STATE OF WASHINGTON
DEPARTMENT OF ECOLOGY

Re: Status of Prospective Purchaser Consent Decree No. 13-2-27556-2 for Alaska Street
Texaco (SKS Shell Station) Cleanup Site located at Alaska Street and Fauntleroy Way
SW, West Seattle, WA

ENC6 – Review of SKS Shell Site
May 15, 2017

Review of SKS Shell Site – 5/15/2017

Enclosures: Site Map and Suggested Groundwater Monitoring Well Locations

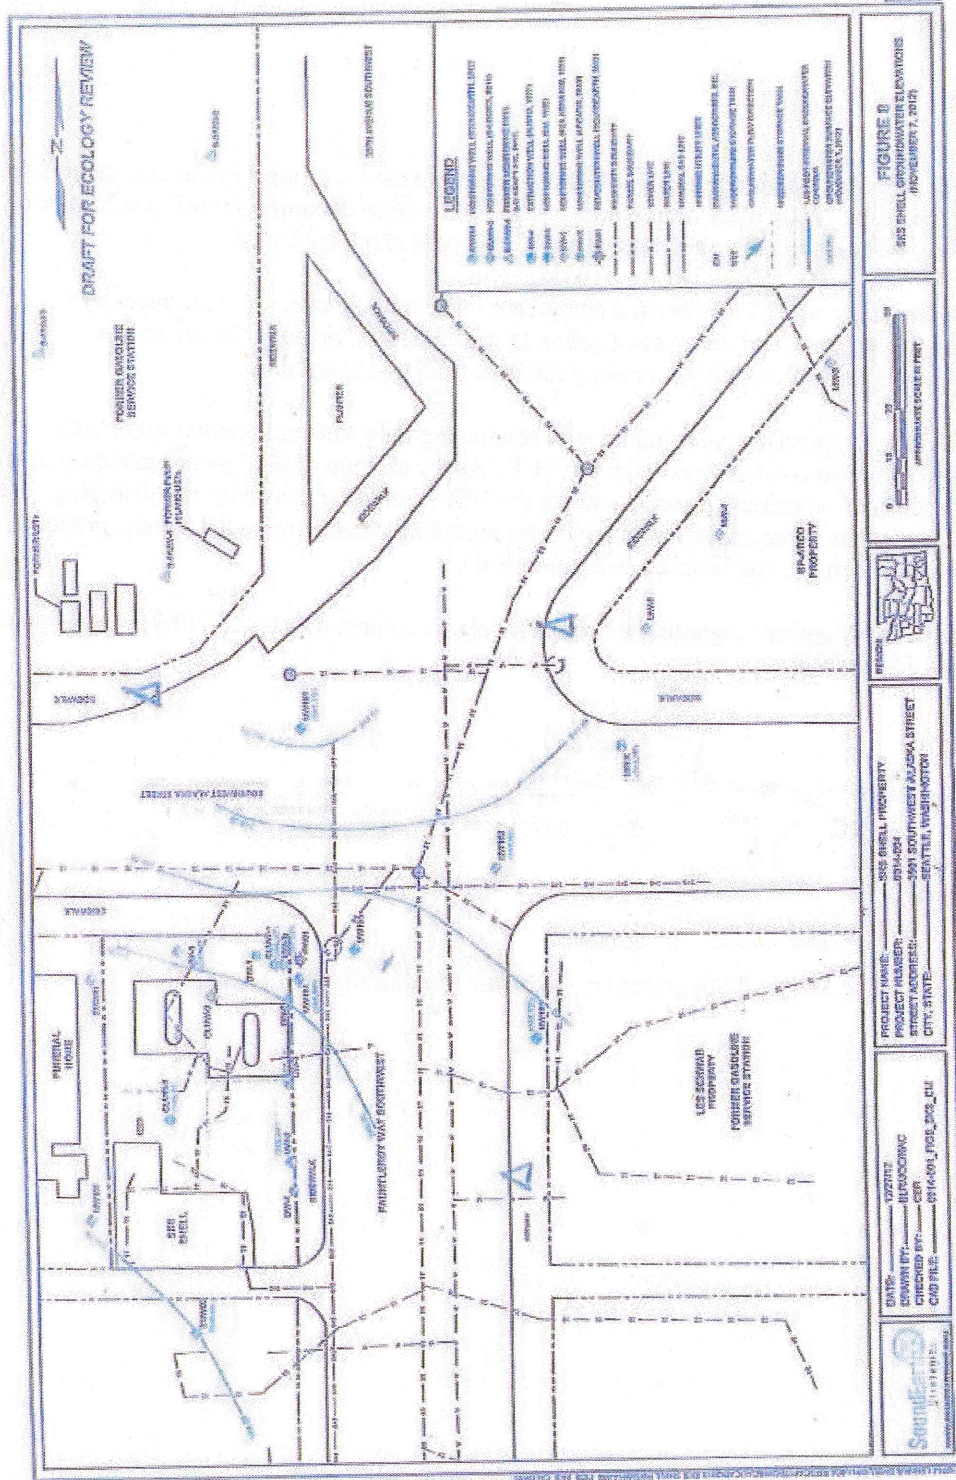
- The vertical and lateral extent groundwater plume is not necessarily adequately characterized at the site. Additional groundwater wells will be necessary to describe the perimeter of the plume. Gasoline contaminated above MTCA cleanup levels in groundwater is observed in wells throughout the SKS Shell property. Groundwater flow is inferred to be north to northeast. Supplemental wells are required north of MW-3, northeast of MW-1 and east of MW-2. All three of the existing wells exceed MTCA cleanup levels. The suggested locations of the new wells are shown as triangles, provided in the attached figure. Additionally, gasoline contamination was also observed in groundwater well SMW04, west of the SKS Shell property. One or more additional wells are necessary too bound the gasoline plume to the west. Additional characterization wells can be installed concurrently with development of the draft cleanup action plan

Figure 1. Estimated drawdown for the dewatering wells.

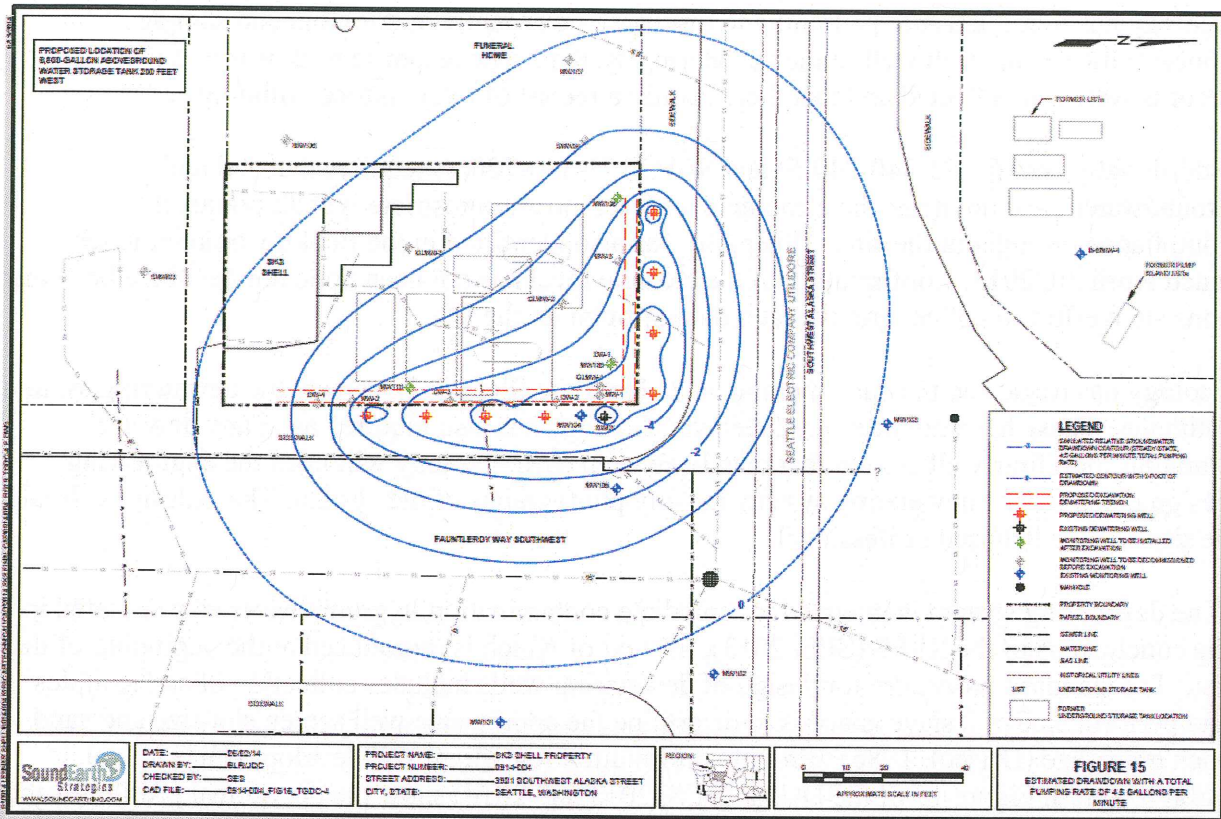
Ecology has requested data pertaining to discharge rate, pumping duration, and sample concentration from each well in the dewatering system. The response back was that these records were not collected and that there is only a record of total volume withdrawn.

Ecology has requested the data, method, and electronic files used to create the dewatering system estimates. These have not been produced yet. Ecology has also inquired as to any dewater planning for a four-well system that may have been used. Ecology will need the engineering design plans for the dewatering system and any photographs of the system. These designs should be signed by a licensed professional.

(The dewatering system is intended to remediate contamination in groundwater as was stated in the conclusions to the RI/FS (SES, 2013), the text of which is reproduced at the beginning of this list. The standard procedure for design of dewatering wells includes collection of soil samples and performance of a sieve analysis to determine the appropriate well screen slot size and sand pack grain size (Driscoll, 1986). Provide information regarding well development (method, turbidity, etc.). Figure 15 of the DCAP (SES, 2013 and 2014) show the drawdown profile for the dewatering well system. The Department of Ecology requires all data used in design of the groundwater dewatering system for both the wells and the drawdown analysis. Provide all data in Microsoft EXCEL electronic format. Provide all input files and calculation spreadsheets, also in electronic format, that were used in the design phase. Design will also include pump selection, and pump performance data (pump make and model, lift, flow range rating, performance curves, etc.). Provide a schematic of the dewatering system that shows well distribution, piping, valves, discharge locations, flow gage locations, sampling ports, and any other pertinent information. Proper design is paramount to an effective remediation system (EPA, 2008, A Systematic Approach for Evaluation of Capture Zones at Pump and Treat Systems). If the dewatering wells are not designed to fit the hydrogeologic system, performance of the remedy is completely unverifiable and indefensible.)

Figure 2. Groundwater flow lines throughout the SKS Shell and Huling Sites.

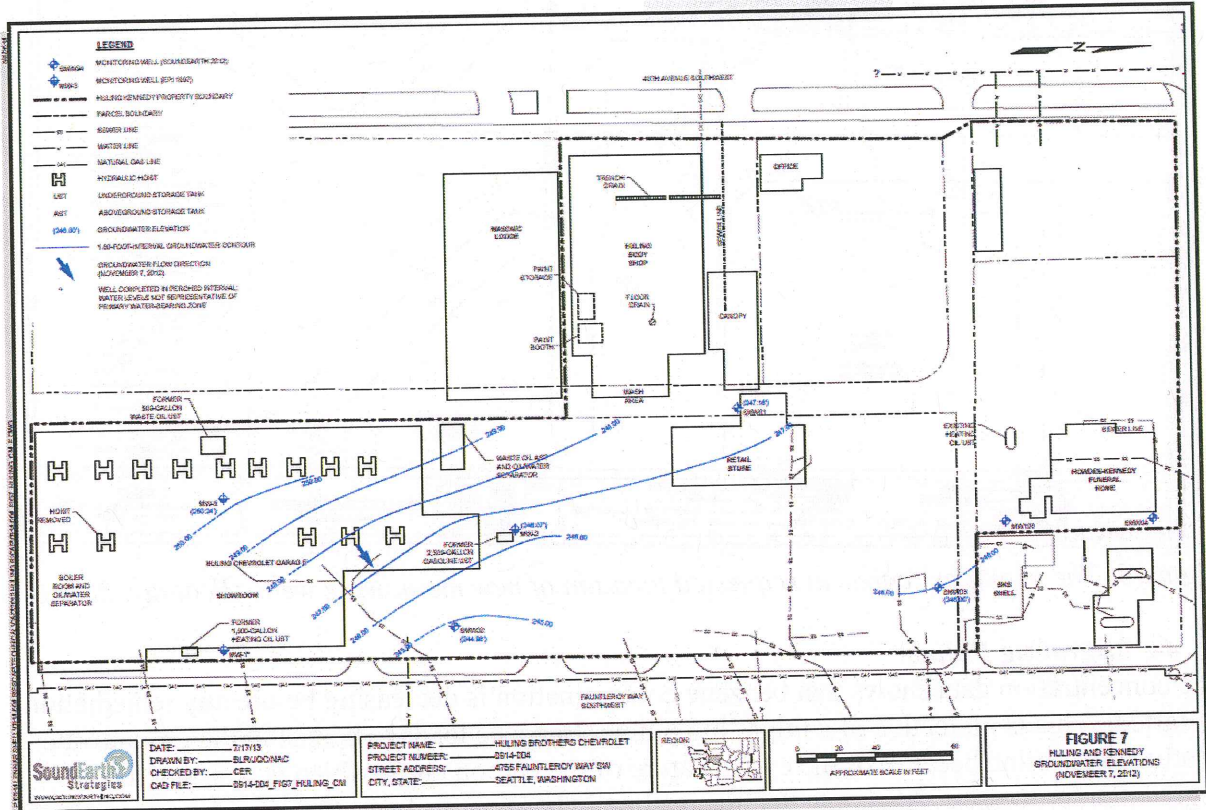
Figure 2 and 3 show groundwater contour features through the SKS Shell and Huling Sites. Effectively the contours represent a gradient, a slope to the water table that together with the effects of gravity drives water and contamination to move in the down gradient direction. Based on the gradient (dh/dl) and we know that a porous media possess a conductivity (Ks) and a porosity (n) the flow rate can be calculated. This calculated value that is derived from Darcy's equation is,

Figure 3. The triangles represent requested location of new monitoring wells (Ecology, 2013)

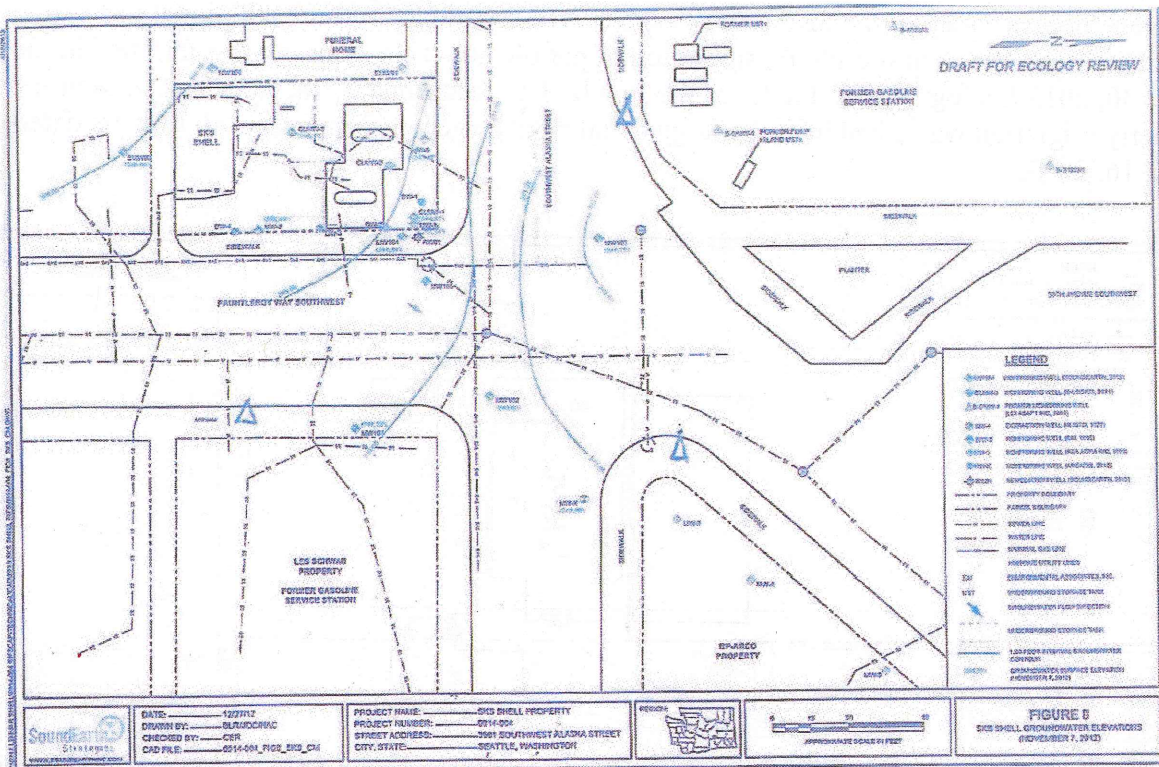
Figure 3. Shows a map of the SKS Shell Property with locations for three additional wells to monitor the perimeter of the site for migration of petroleum. This request was submitted in the April 30, 2013 Ecology opinion letter as the first bullet. Additionally, the concern to monitor off property migration was noted in an Ecology email from Eugene Freeman to Rob Roberts dated April 16, 2013.

Figure 4. Gasoline and benzene concentration at MW-104.

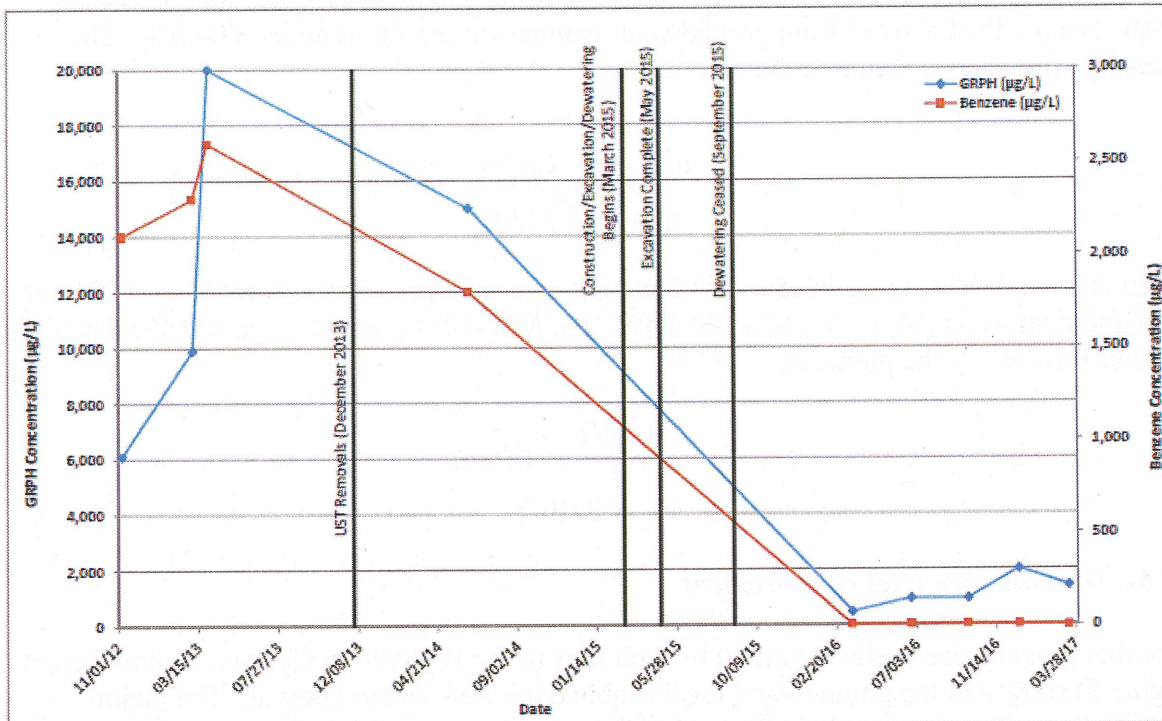
The concentration data shows that benzene contamination is decreasing before any remediation is started. This is indicative of a migrating plume. Benzene tends to persist in the groundwater relative to gasoline because of the cyclic nature of the carbon chain which is resistant to degradation processes. Also note that the decline in benzene and gasoline are approximately the same. Gasoline, being a linear carbon chain should break down faster than benzene. The graph shows benzene and gasoline both decrease at about the same rate, also suggesting that the plume is migrating.

Also note that if dewatering was having a significant effect of the contamination in groundwater, there should be an increase in the slope of contaminant concentration decline that reflects reduction. The plot does not show any change in the slope during or after dewatering begins.

Figure 5. Water level relative to screen location.

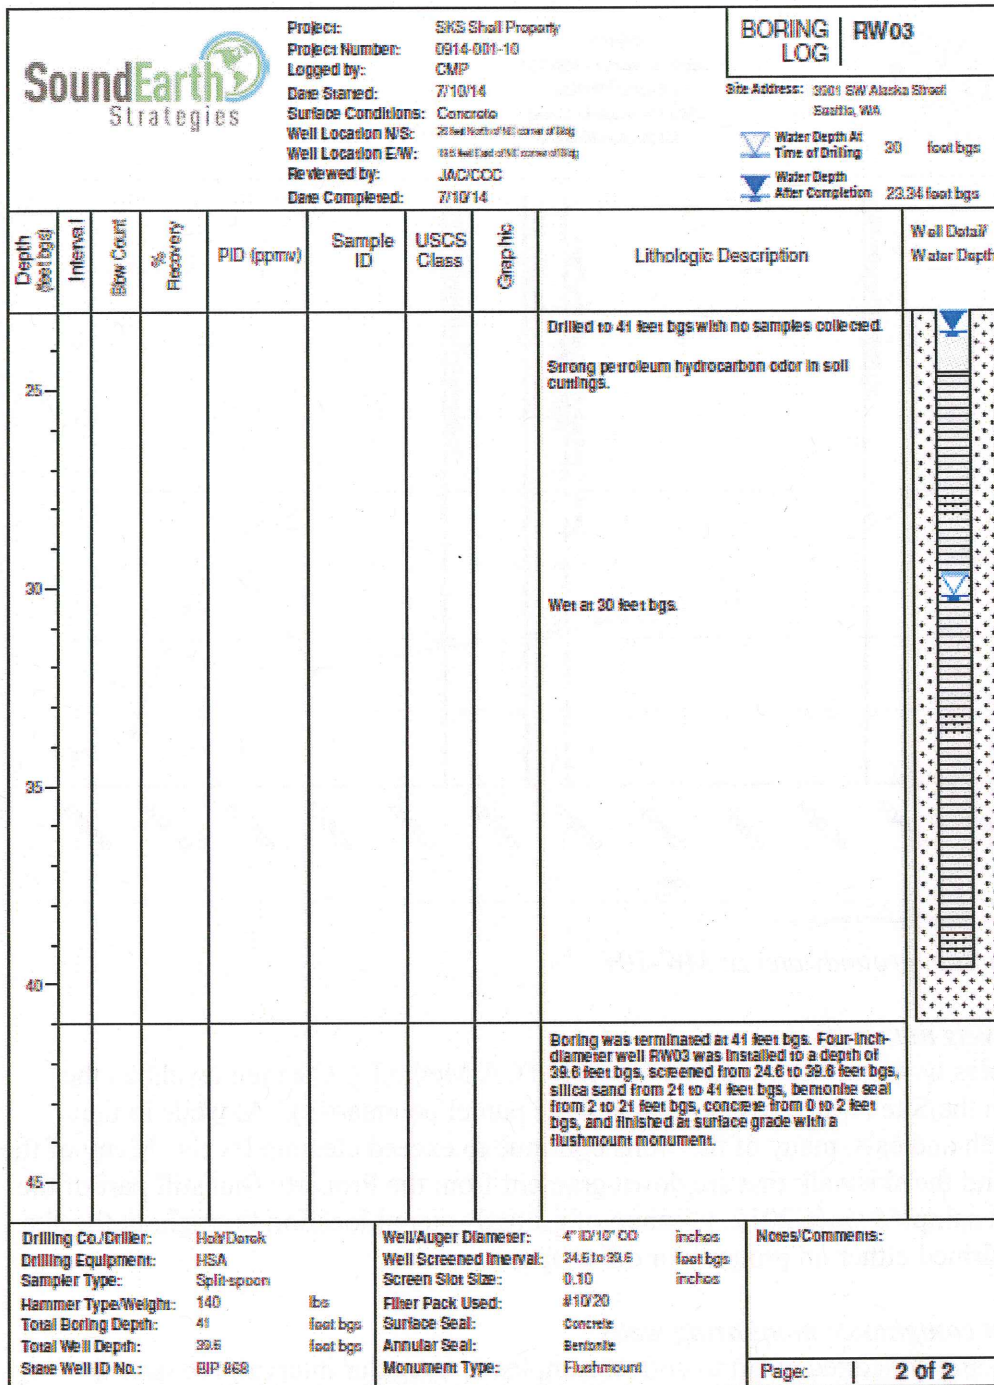
Note that groundwater wells identified by well logs in the 10/20/2016 Cleanup Action Report (Figure 5) show that the groundwater level is above the well screen interval. The major contaminants of concern are LNAPL, which flows on the water. Therefore, sampling from these wells may be expected to under-represent contaminant concentration in groundwater. The figure below shows one of those wells where groundwater is above the screen. This groundwater position above the screen is observed in multiple well completions.

SES notes that the contaminant concentrations in groundwater samples has been increasing with decline in water level. This could be the result of the water table dropping into the screened interval and consequently, the lighter petroleum is now being captured during sampling.
